Re: Appeal of City of Oregon City File DP 16-03, Detailed Development Plan

Re: Appeal of City of Oregon City File DP 16-03, Detailed Development Plan Appeal

STREET RESTORATION EXHIBIT

To: Wendy Marshall, Development Projects Manager, City of Oregon City
From: Weston York, Senior Construction Manager, PH&S
CC: Mike Robinson, Attorney, Perkins Coie
Date: 2/8/17, Revised 2/24/17
Re: **PH&S RESPONSE TO DDP APPEAL (City of Oregon City File No. A-16-02)**

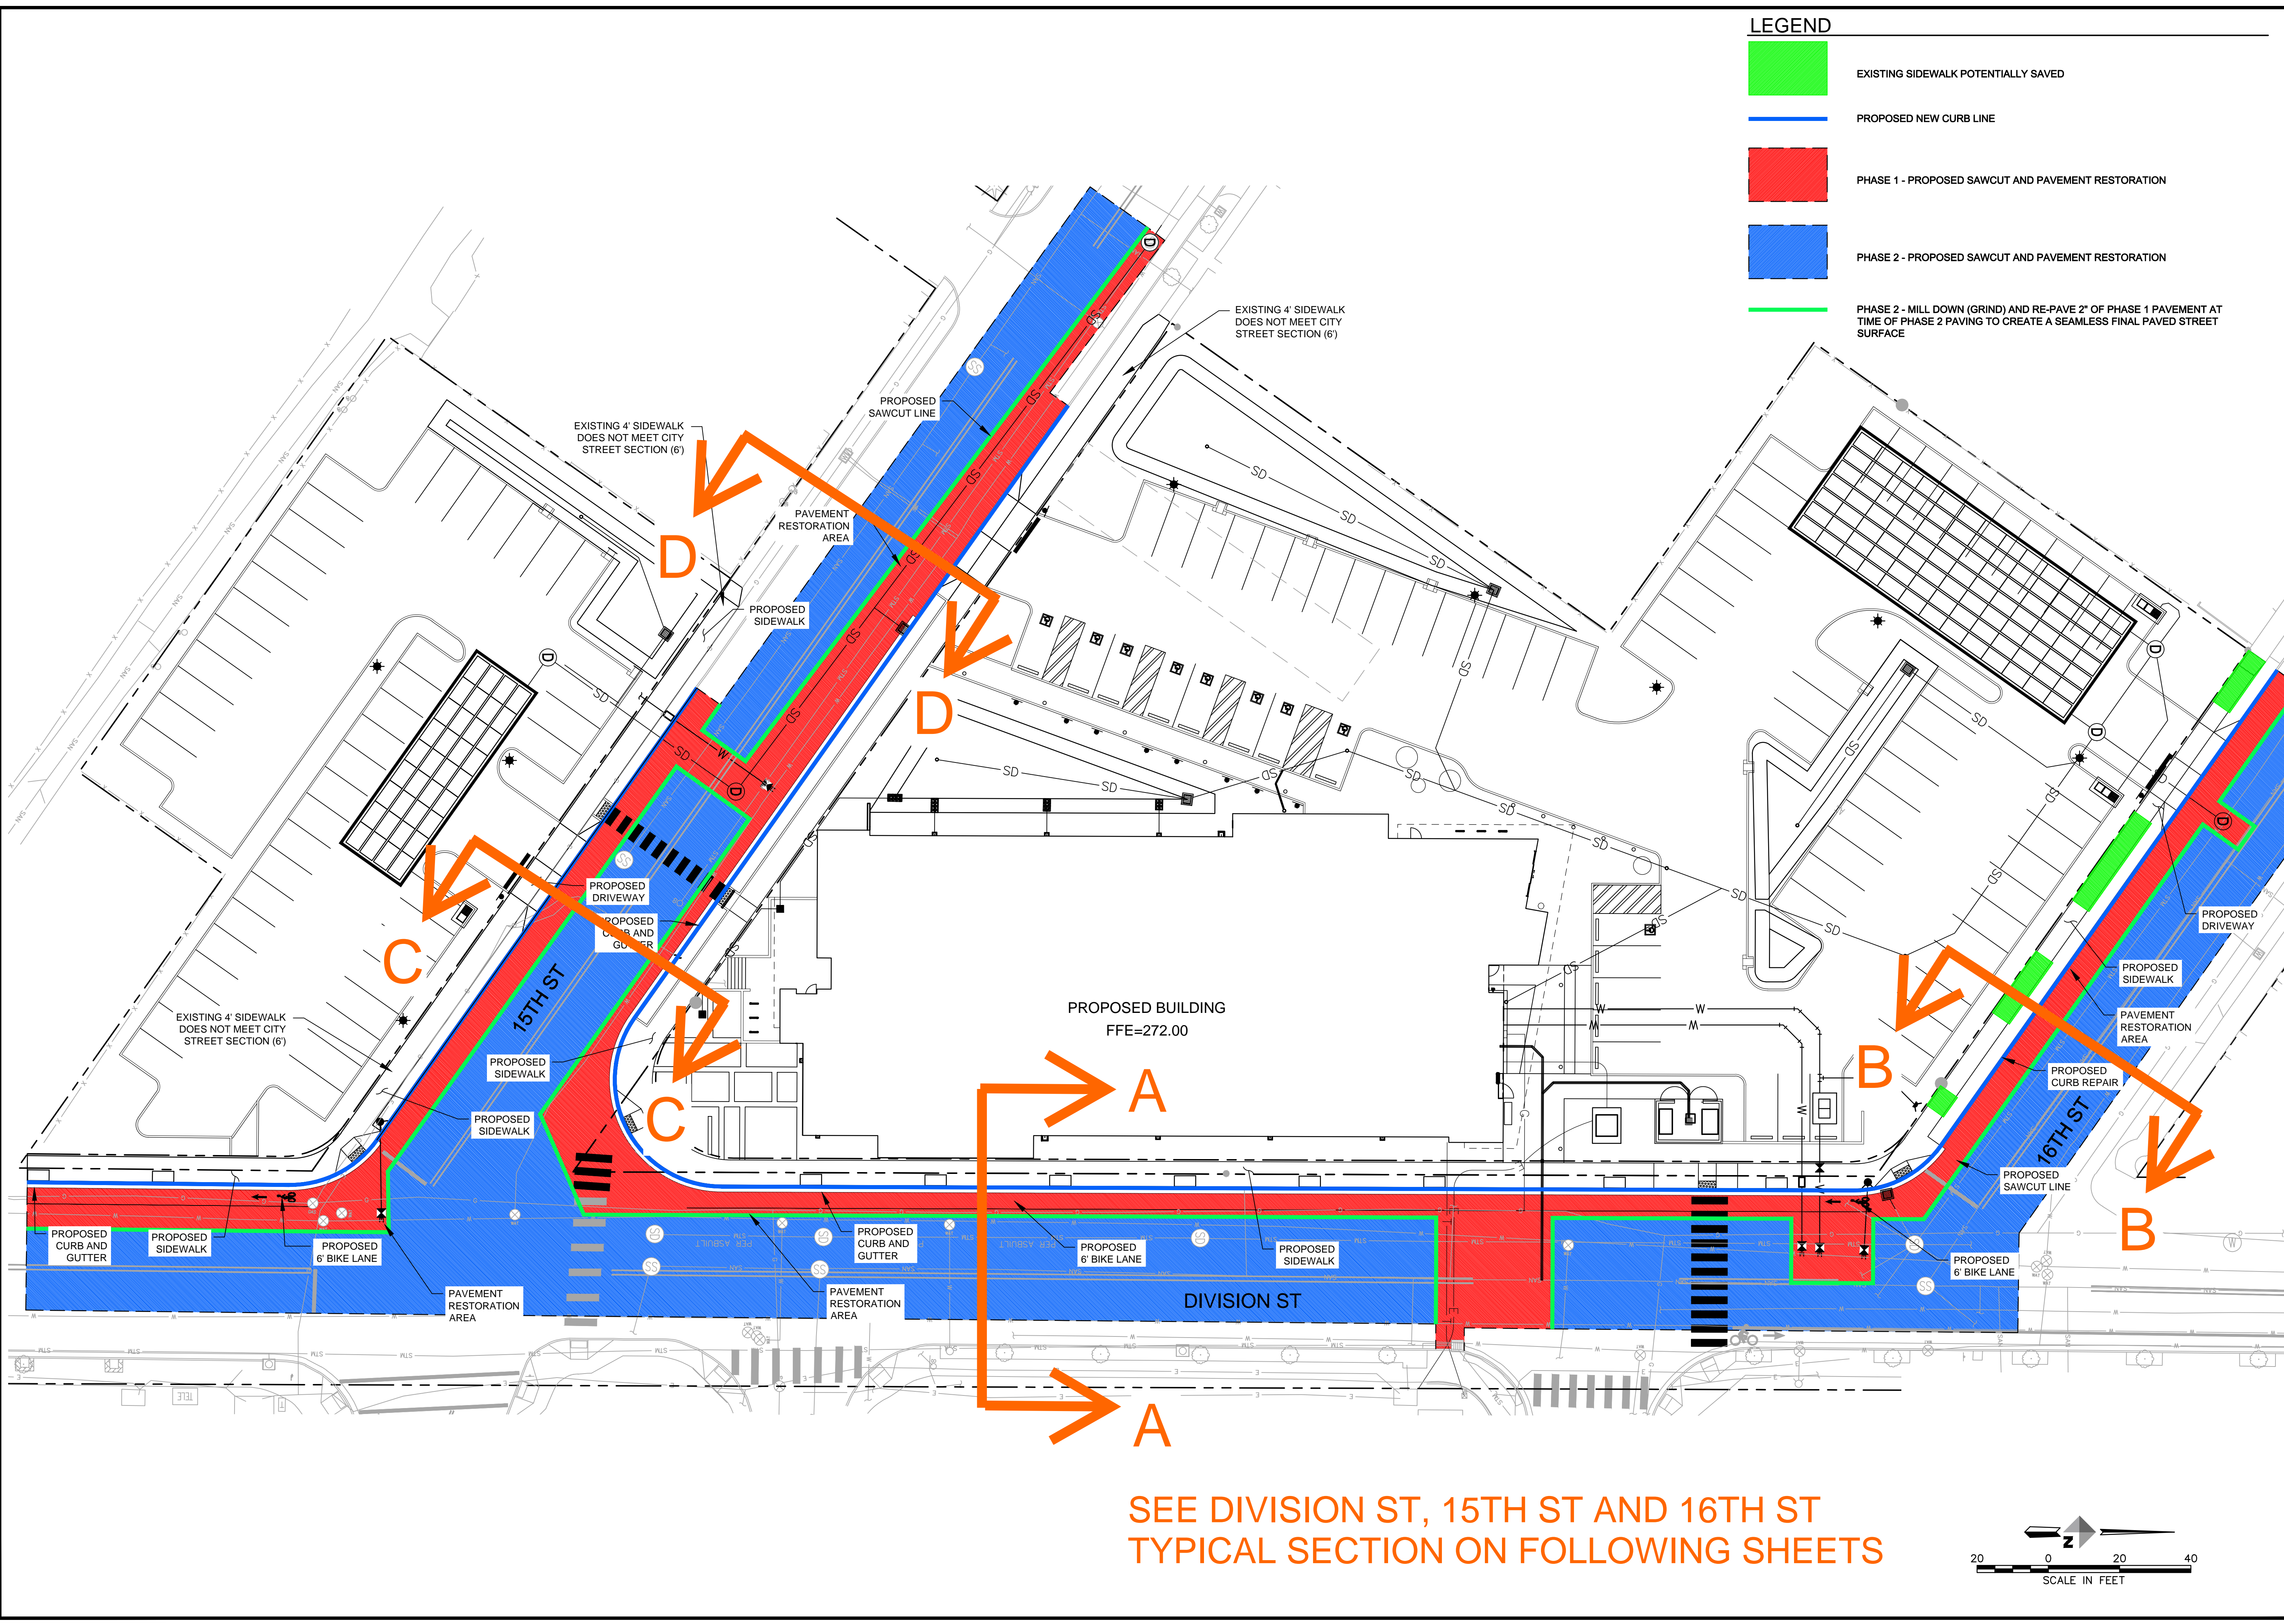
5. *The proposal for minimum pavement patching for 2017 (pink areas on the Timeline Sketches), does not meet our minimum pavement patching standards. In particular, refer to the below highlighted sections regarding dimensional requirements. Longitudinal patches have to be at least 8 feet wide, patches within 30 feet of each other need to be combined into one, and a patch needs to extend to the nearest lane line, so as not to result in a seam within the wheel path.*

6. *The full restoration to be completed in 2018 (blue areas on the Timeline Sketches) is shown 10 feet beyond centerline. As stated previously, and shown on the attached Proposed Street Restoration Exhibit, the City is only requiring you to provide the restoration to the centerline (except where the development fronts both sides of 15th Street, where it is required from curb to curb).*

7. *Once you adjust the patching limits to meet the City’s minimum pavement patch standards, and adjust the full depth restoration to only go to the centerline, the difference in scope between the City’s required improvement and the applicant’s proposed improvement becomes very small.*

See attached .pdf document “MOB Street Paving and Paving Sections 2017-02-24” for specific phasing of the work. The 2017 and 2018 references have been removed, with the only milestone for completion being October 31, 2018. For the section on 15th Avenue, we have updated the work to meet the 8’ minimum requirement. We are asking for a one-year exemption for the gap between this line and the edge of the bike line, as we will be coming back the following year to complete the full section of road improvements. Please review and advise if this is acceptable.

PH&S is detailing the street improvement work to comply with the 2021 Master Plan agreement that we have with the City of Oregon City. The Master Plan requires PH&S to repave to the lines indicated on the section drawings, not to the centerline. See attached .pdf document “MOB Street Paving and Paving Sections 2017-02-24” for extent of pavement restoration.

See attached .pdf document “MOB Street Paving and Paving Sections 2017-02-24” for extent of pavement restoration. Please review for compliance with the City’s required improvements.
